**Town of Kittery
Planning Board Meeting
January 11, 2024**

ITEM 1—181 State Road—Marijuana Business Plan — Preliminary Review

**RE: Preliminary Site Plan Review – Review Revisions
Indico Adult-Use Marijuana Retail
181 & 185 State Road, Kittery, Maine (Tax Map 28, Lot 14-2)**

**RE: Town of Kittery, Planning Board Services
Indico Adult-Use Marijuana Retail Review
181 & 185 State Road (Tax Map 28, Lot 14-2)
CMA #591.170**

SEWER PIPE TRENCH
(NTS)

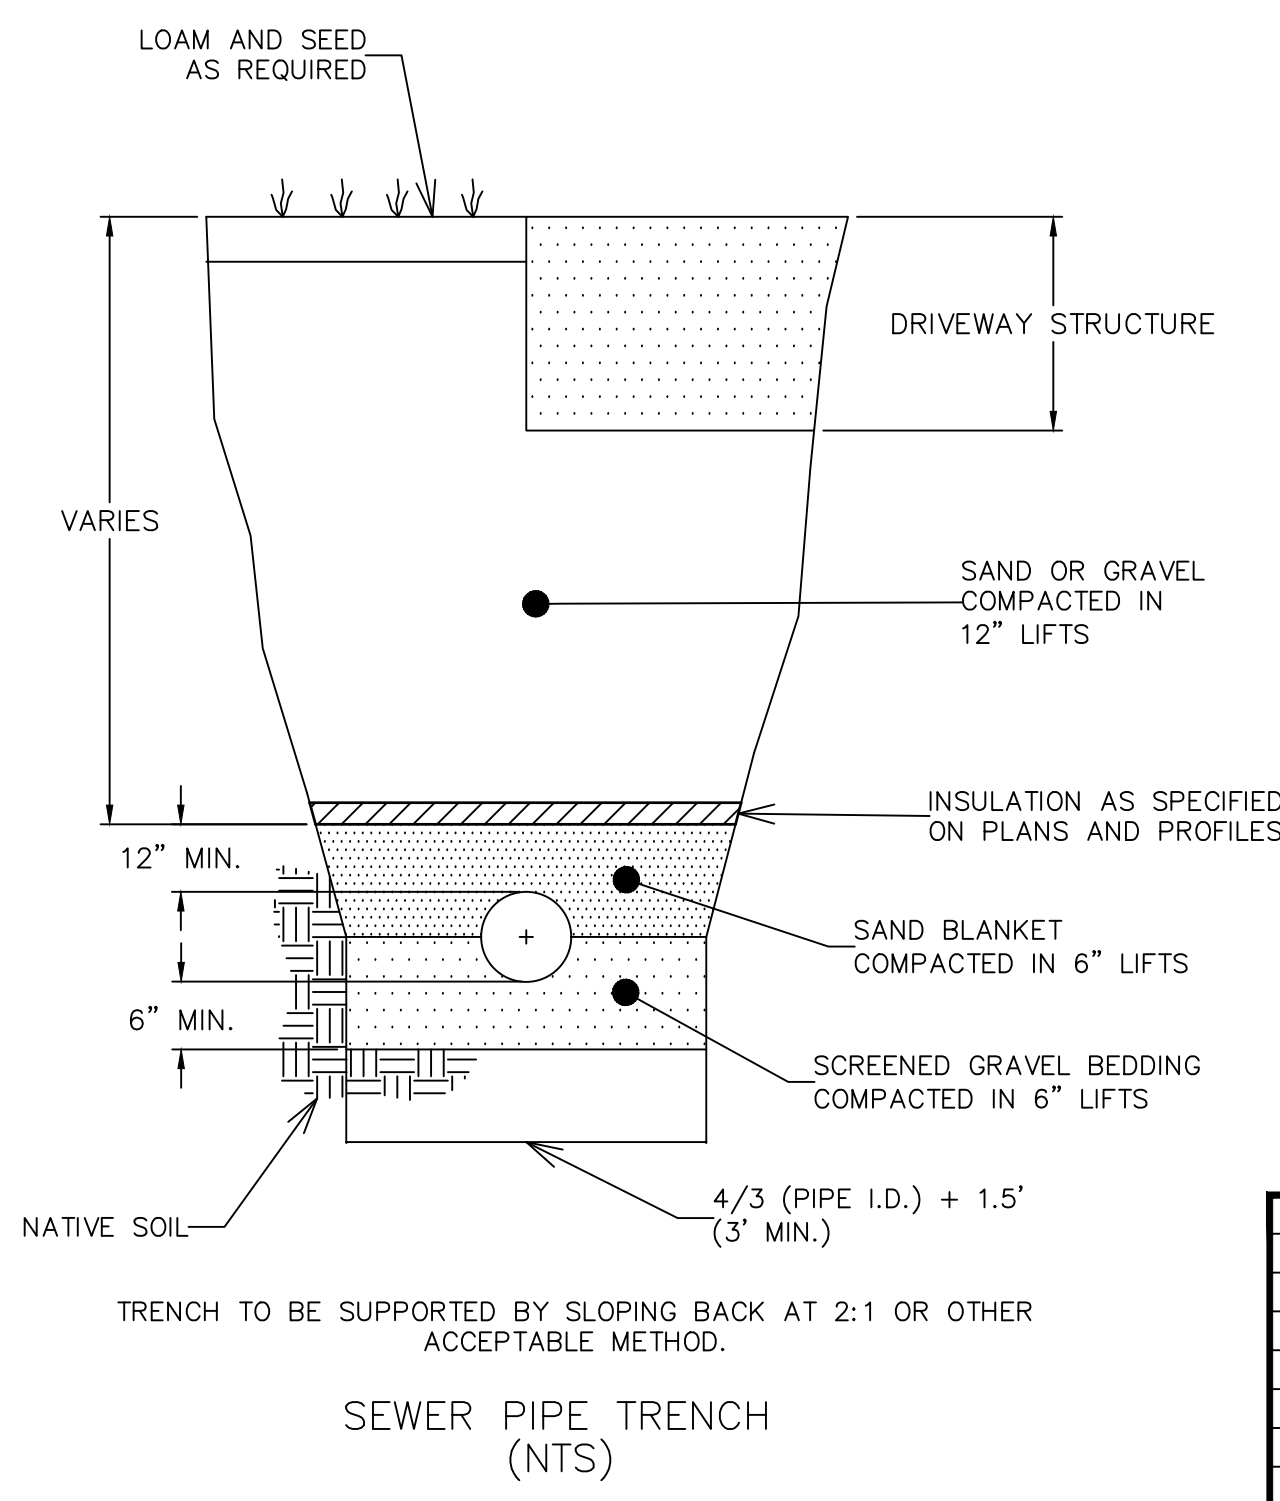
3. The Sewer Pipe Trench detail should specify the gravel. Add warning tape.
4. The Water Service Detail shows a PVC distribution main and 1" copper service. Are these features correct?

TYPICAL CATCH BASIN
(NTS)

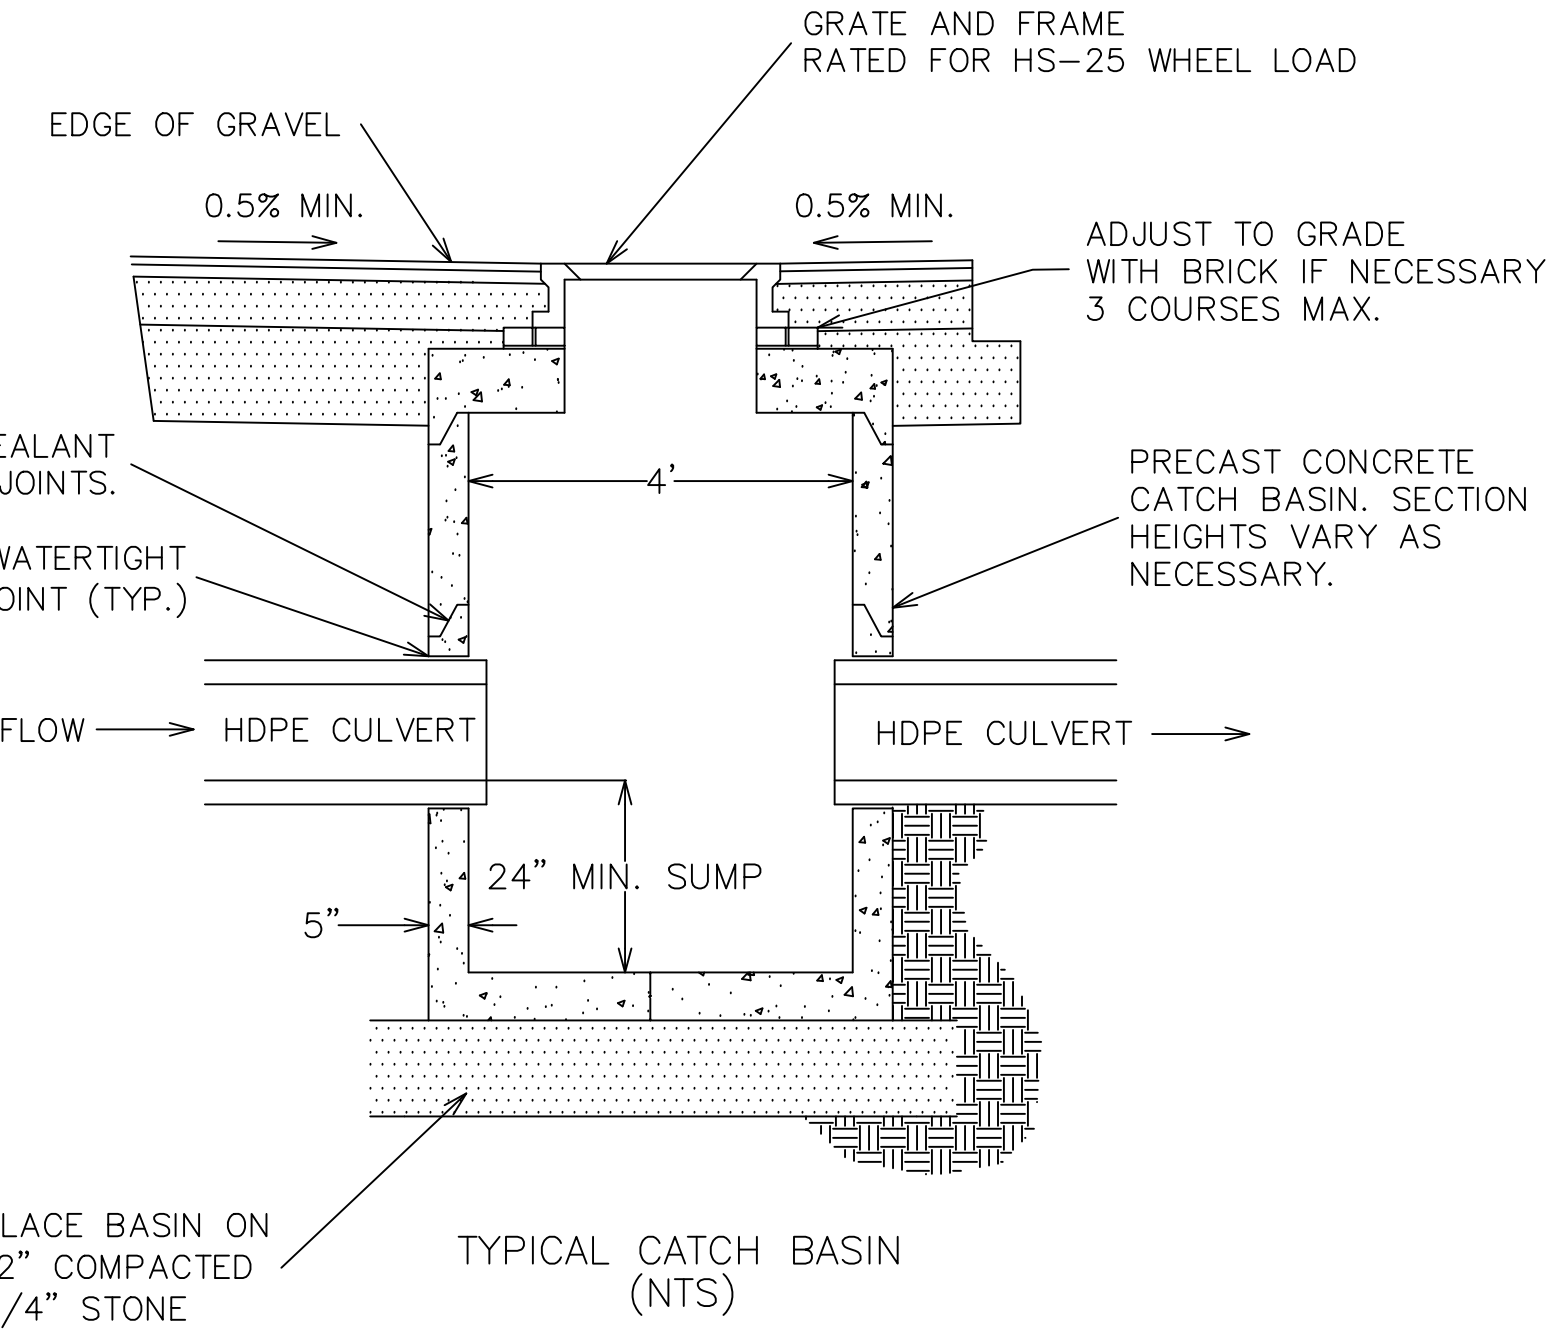
5. The Typical Cath Basin detail should specify the frame and grate type.
6. The Typical Sanitary Manhole detail should reference the Standard Cover and Frame detail.
